**CITY OF TEMPE
DEVELOPMENT REVIEW COMMISSION**

**Meeting Date: 04/28/2015
Agenda Item: 3**

ACTION: Request for a Development Plan Review for building elevations, site plan and landscape plan, and a Use Permit Standard for an increase in building height from 30 to 33 feet, consisting of 15 single family attached townhomes for THE BLOCK ON ROOSEVELT, located at 233 South Roosevelt Street. The applicant is Scott Garvin of Intent Development Advisors.

BACKGROUND INFORMATION: THE BLOCK ON ROOSEVELT (PL140336) is a multi-family residential through lot within the Riverside Neighborhood Association. The request includes the following:

NORTH ELEVATION UNITS 9-15

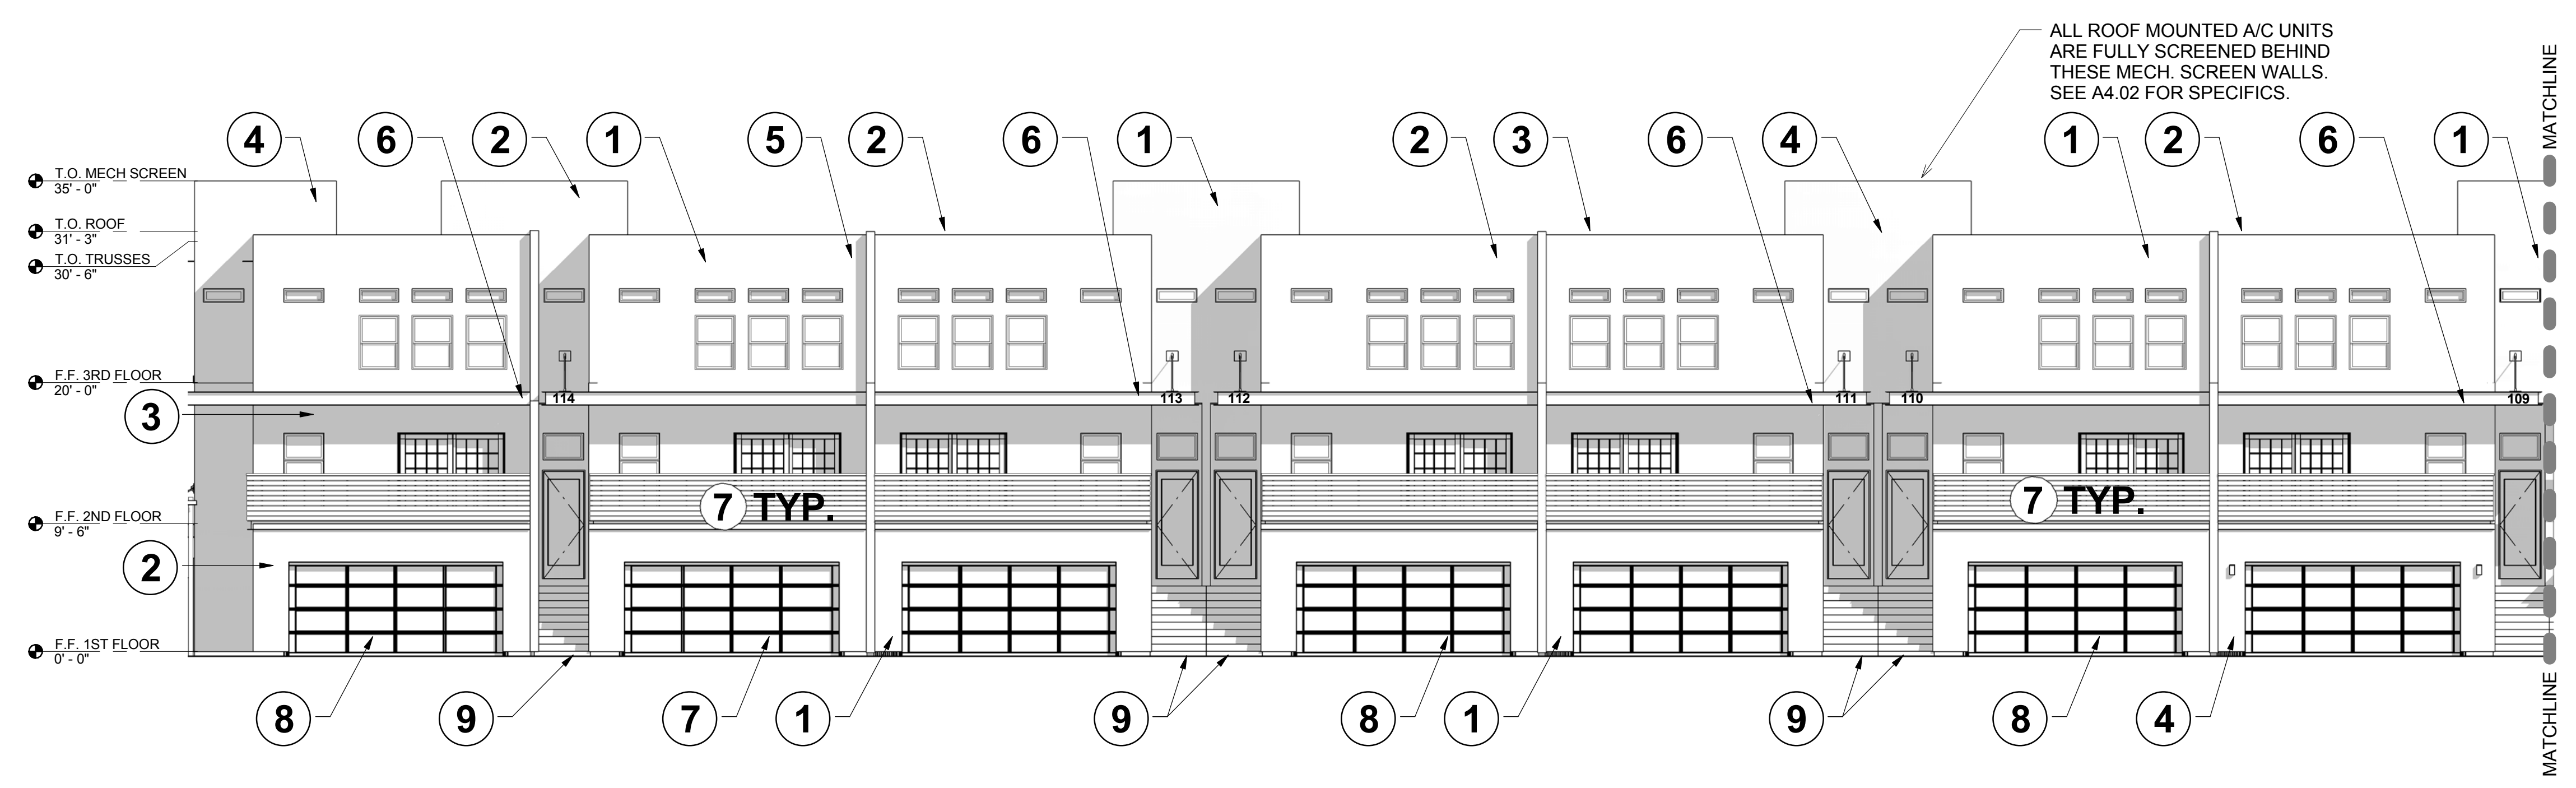
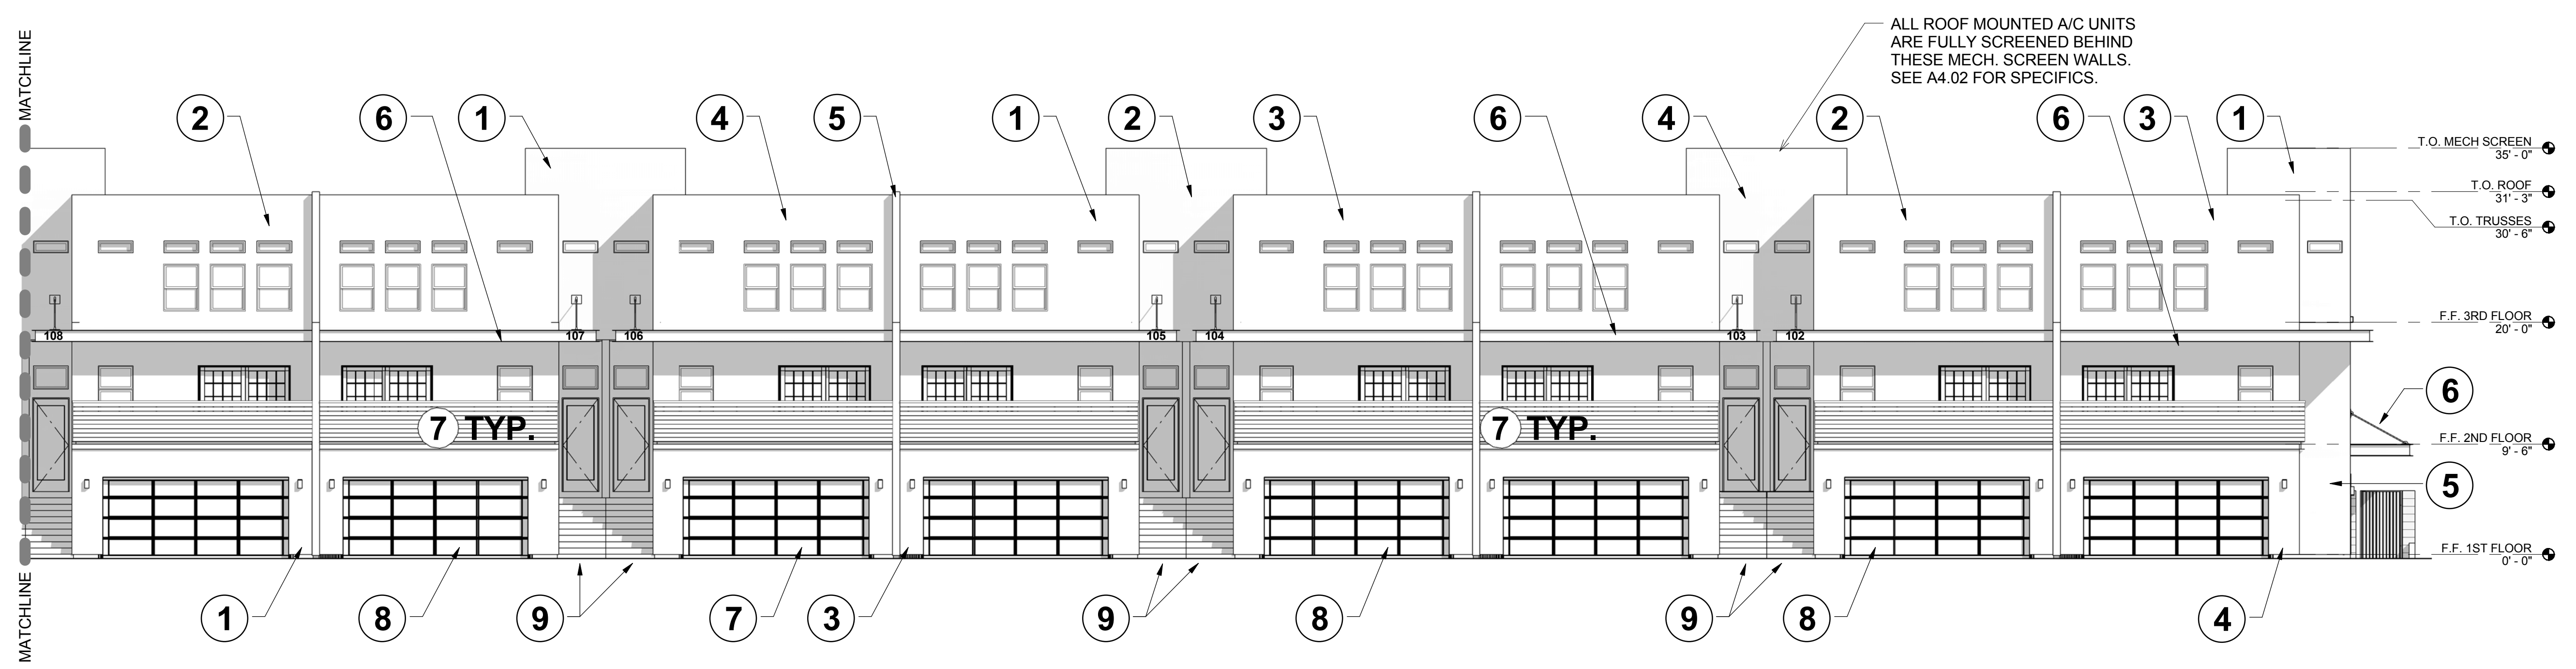
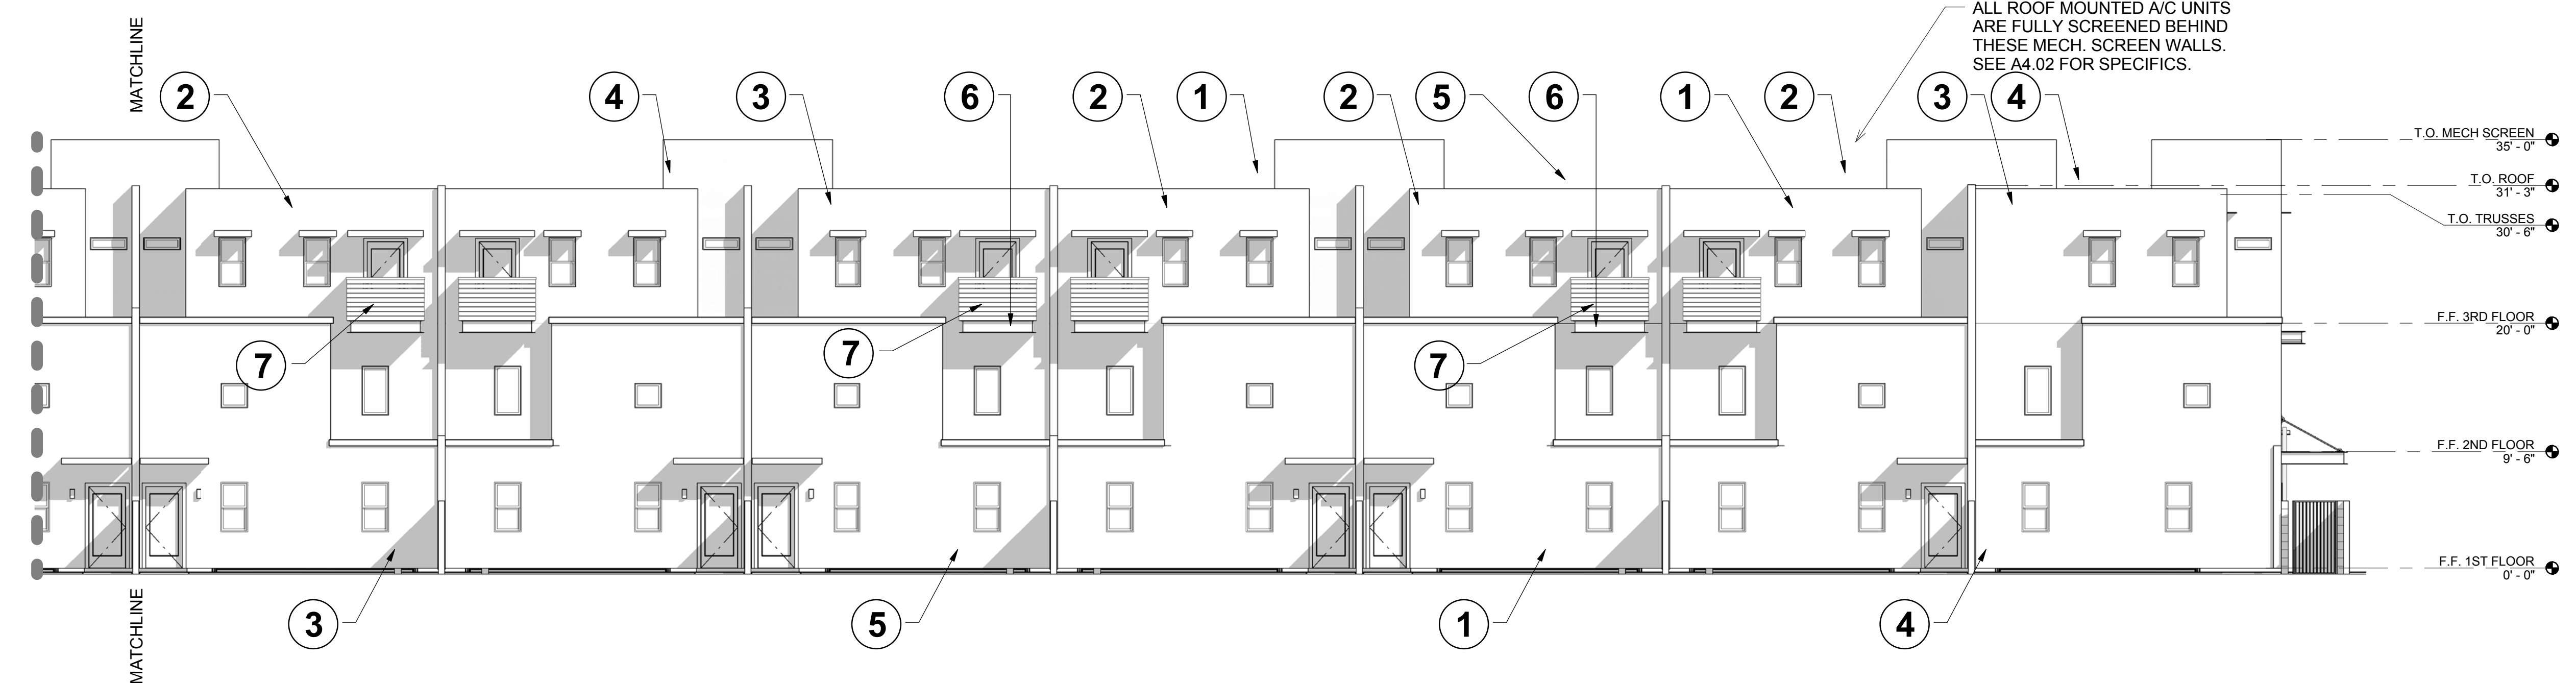
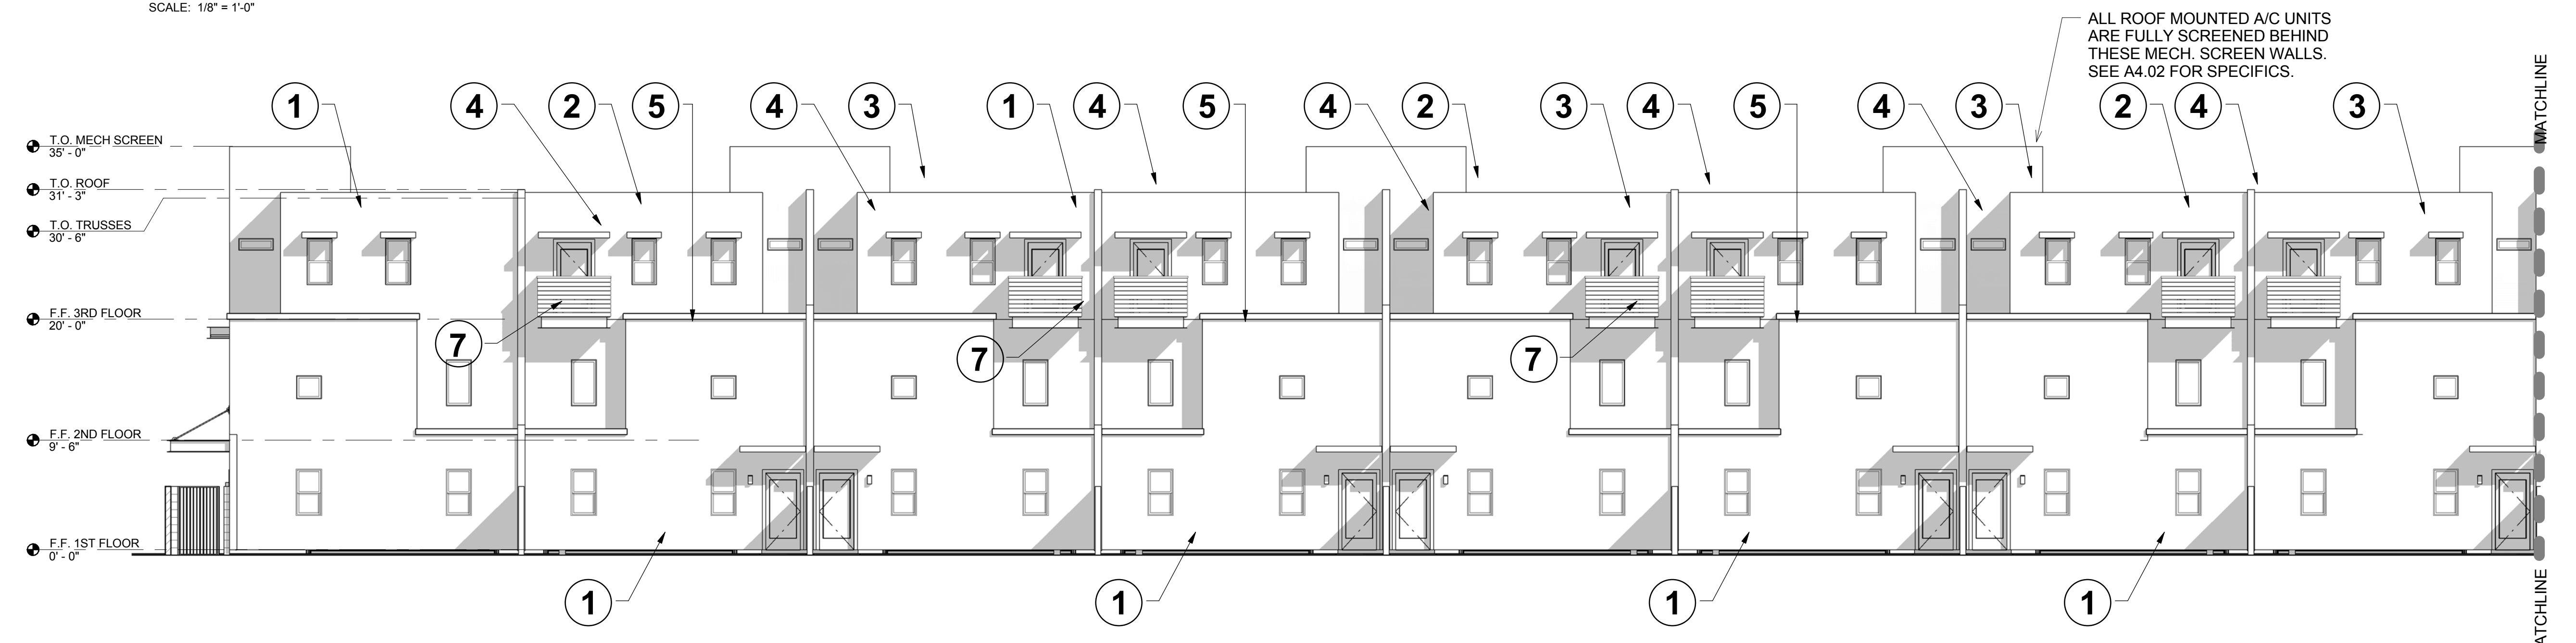
13. The materials and colors are approved as presented (April 14, 2015) with exceptions as noted:
 - Roof – flat painted white, with parapet screening of HVAC

- Primary Building – Painted Stucco Color #1 Sherwin Williams 6007 White Smart (pale mauve)
Provide an alternate color within a contrasting color tone such as blue or green in the same tonal range (as presented on earlier April 10, 2015 elevations)

- Primary Building – Painted Stucco Color #2 Sherwin Williams 6009 Imagine (light taupe)
 - Primary Building – Painted Stucco Color #3 Sherwin Williams 6011 Chinchilla (medium taupe)

- Primary Building – Painted Stucco Color #4 Sherwin Williams 6013 Bitter Chocolate (dark brown) – provide this color as an accent color, not primary building color

- Smooth-faced CMU standard grey to be replaced with split or ground faced CMU on first floor, and integral colored block for the building elevations for enhanced architectural detail.
